Figure 149-3—PCS reference diagram

149.4.2.4 PHY Control function

Figure 149-nn4 – CRC16

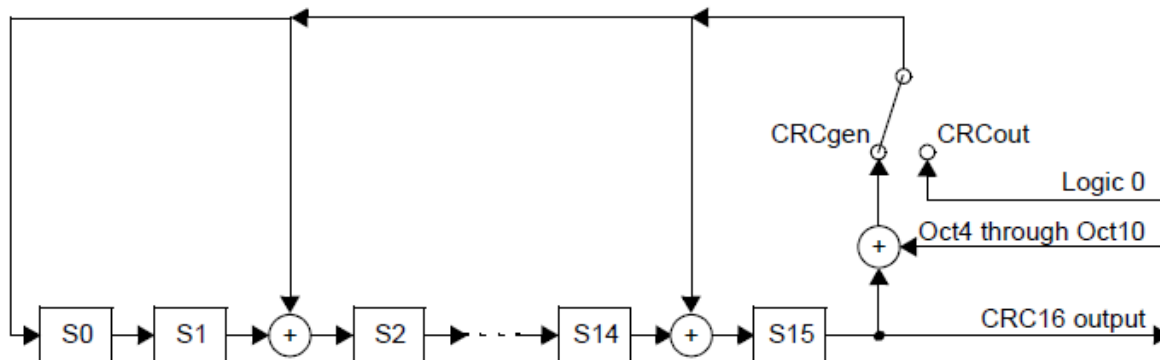
[To Editor: please copy Figure 97-23 as Figure 149-nn4.]

CRC16 (2 octets) shall implement the CRC16 polynomial $(x+1)(x^{15}+x+1)$ of the previous 7 octets, Oct4<7:0>, Oct5<7:0>, Oct6<7:0>, Oct7<7:0>, Oct8<7:0>, Oct9<7:0>, and Oct10<7:0>. The CRC16 shall produce the same result as the implementation shown in Figure 149–nn4. In Figure 149–nn4 the 16 delay elements S0,..., S15, shall be initialized to zero. Afterwards Oct4 through Oct10 are used to compute the CRC16 with the switch connected, which is setting

CRCgen in Figure 149–nn4. After all the 7 octets have been processed, the switch is disconnected (setting CRCout) and the 16 values stored in the delay elements are transmitted in the order illustrated, first S15, followed by S14, and so on, until the final value S0.
